AGENDA  
City of Milton  
Plan Commission  
Tuesday, March 15, 2016  
5:00 pm  
MILTON CITY HALL  
Council Chambers, 710 S. Janesville Street

**To:** City of Milton Plan Commission  
**From:** Howard Robinson, Director of Public Works  
**Date:** March 8, 2016  
**cc:** Mayor Anissa Welch, Common Council Members  
**Subject:** Discussion and Possible Action on a Site Plan Review for the Milton East Parking Lot Reconfiguration.

# MILTON EAST ELEMENTARY ACCESS IMPROVEMENTS

**MILTON EAST ELEMENTARY SCHOOL**  
**PROPOSED PARKING LOT IMPROVEMENTS**  
**CONCEPTUAL VERSION 5 (FINAL)**  
**SCHOOL DISTRICT OF MILTON**  
**MILTON, WI**

**SITE AND GRADING PLAN**  
MILTON EAST ELEMENTARY ACCESS IMPROVEMENTS  
SCHOOL DISTRICT OF MILTON  
MILTON, WISCONSIN

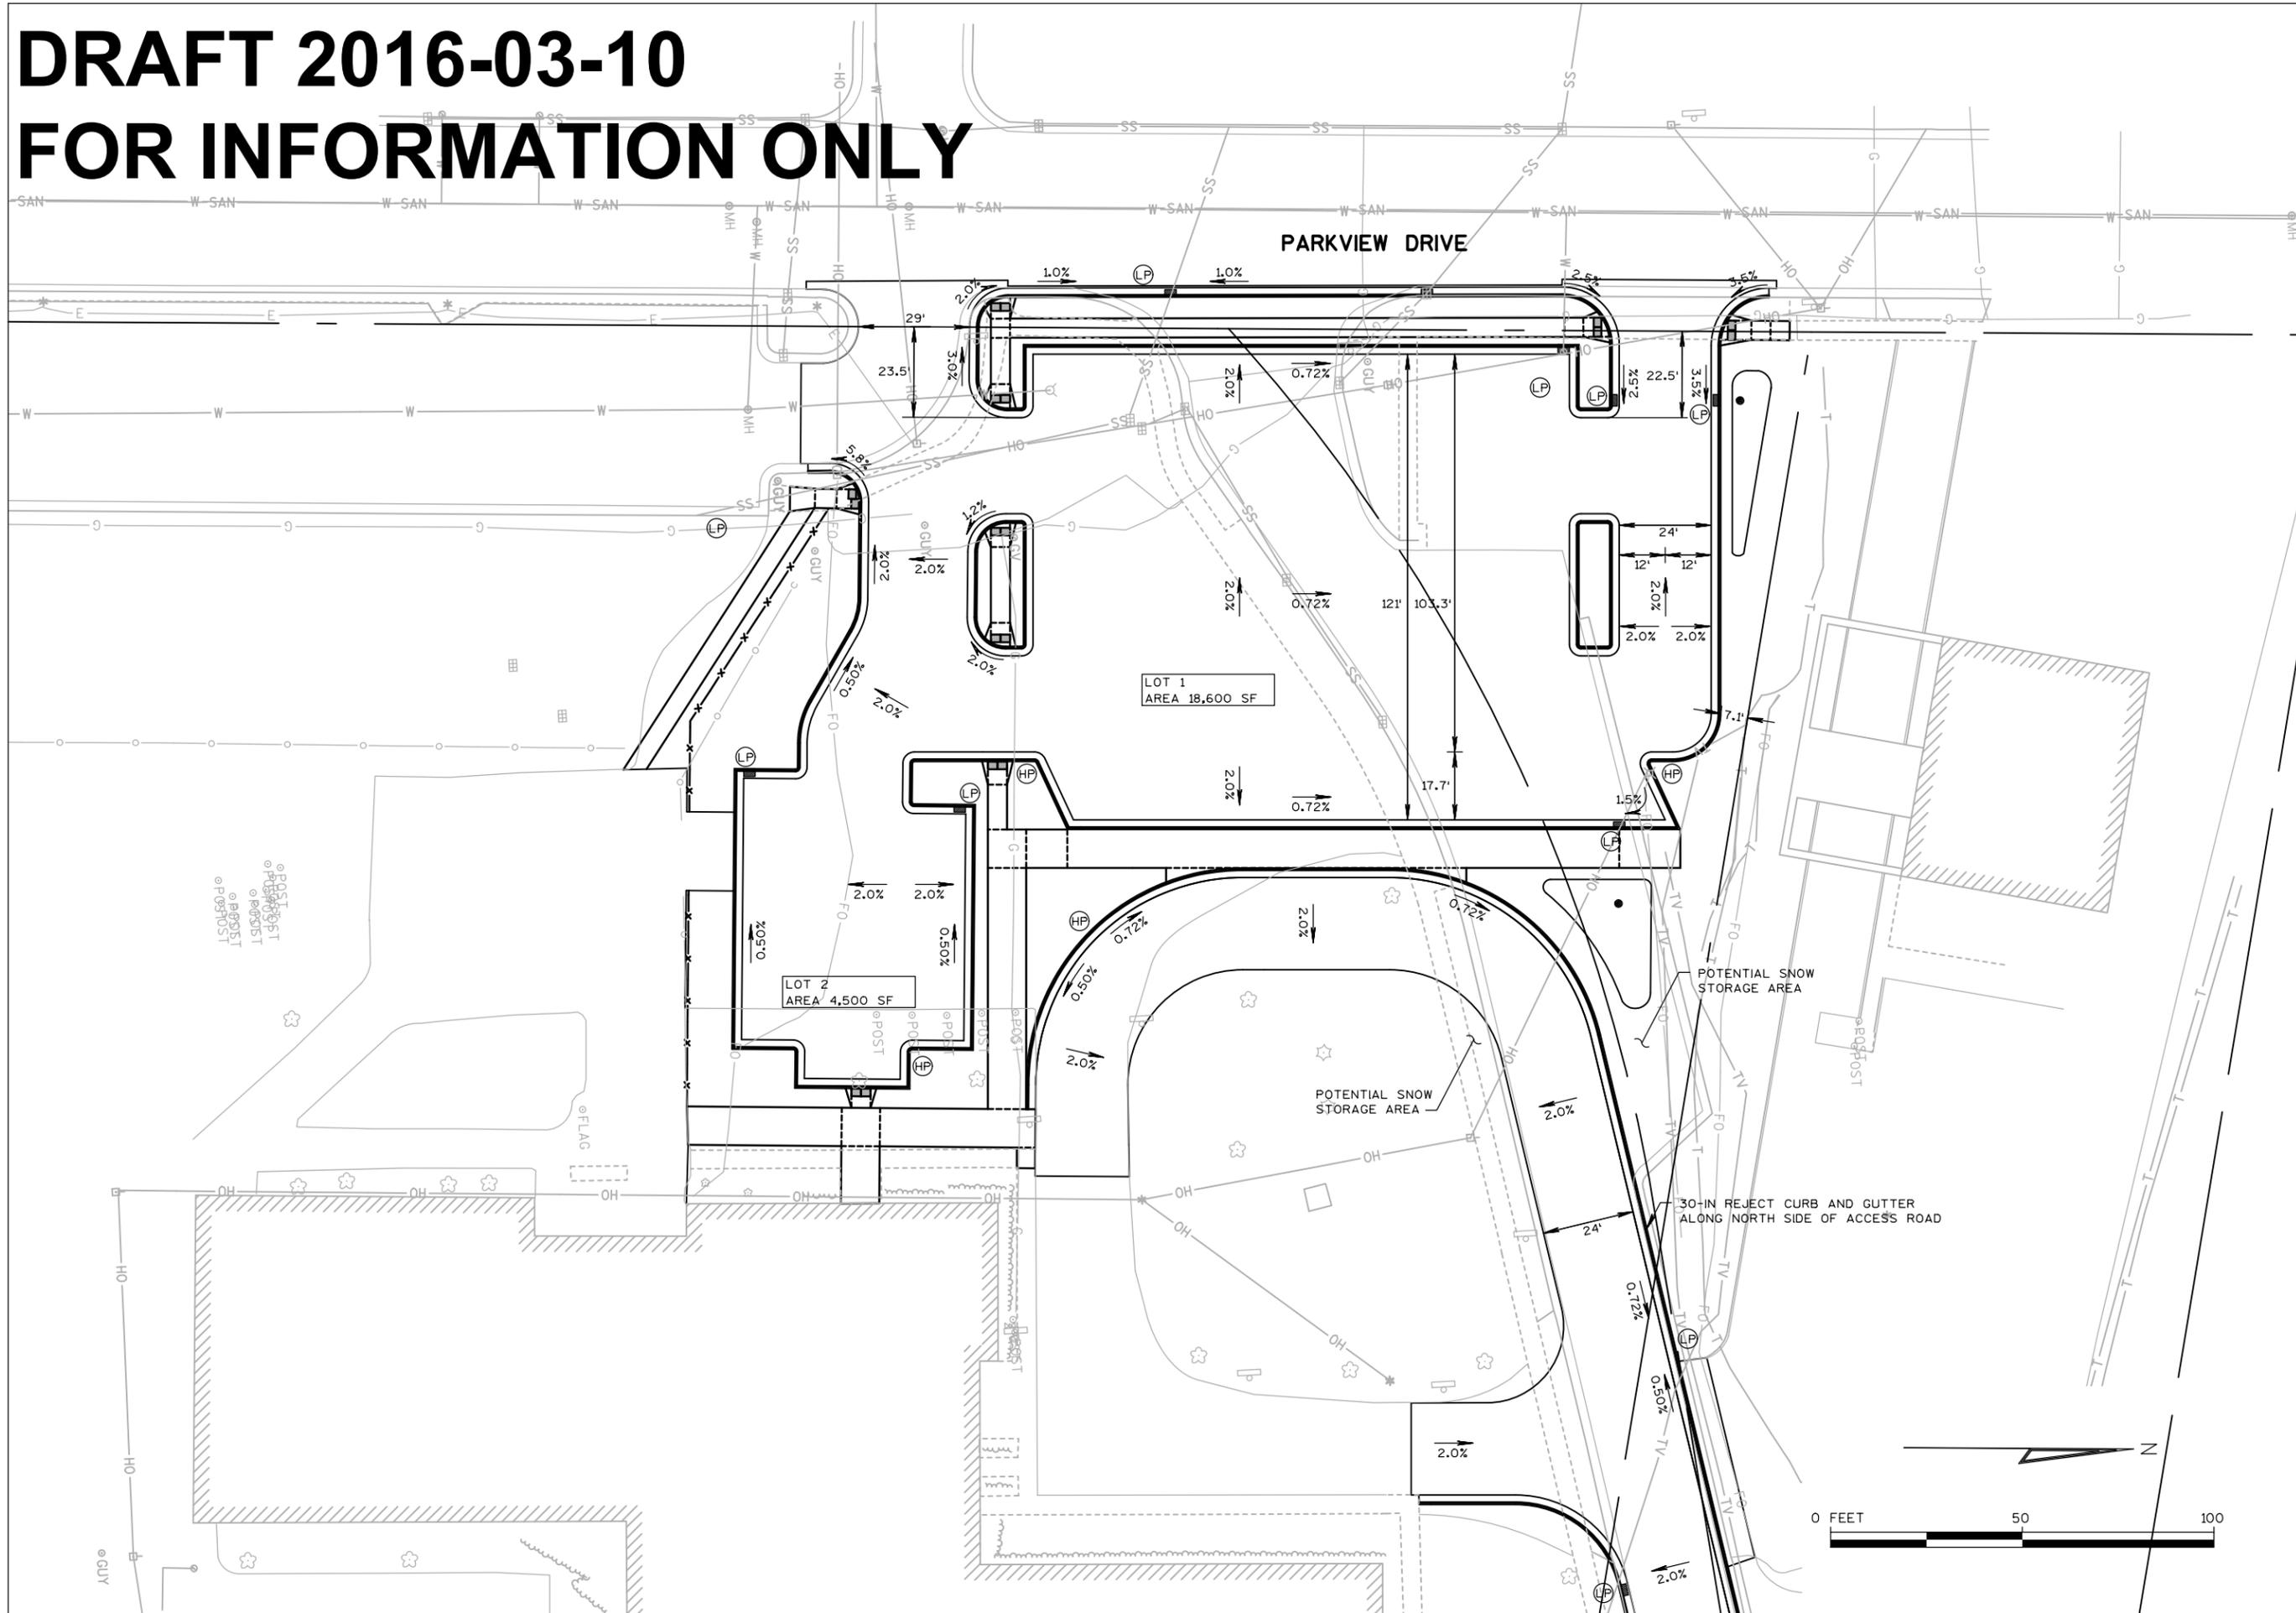
The Milton School District has submitted a parking lot plan to the city. A parking lot plan for a commercial building requires a site plan review. They have submitted a base overview plot plan of the proposed parking lot. We have informed them of some additional information we require to have a complete site plan.

We need more information on:

- Dimensions of the stalls
- Driveway dimensions
- The distance of the driveway throat entrances from the street
- Where lights are planned
- Where future sidewalks are planned
- Where snow will be stored
- Where the storm water will be drained
- What utility mains (storm water) may be installed
- A landscape plan
- Setbacks from the property lines
- An overall square footage of the paved areas
- An easement agreement for the parking lot and/or driveway use

They are working with Strand Engineering to supply these items. If they are submitted before Plan Commission meets we will try and email you a new memo and plan to review.
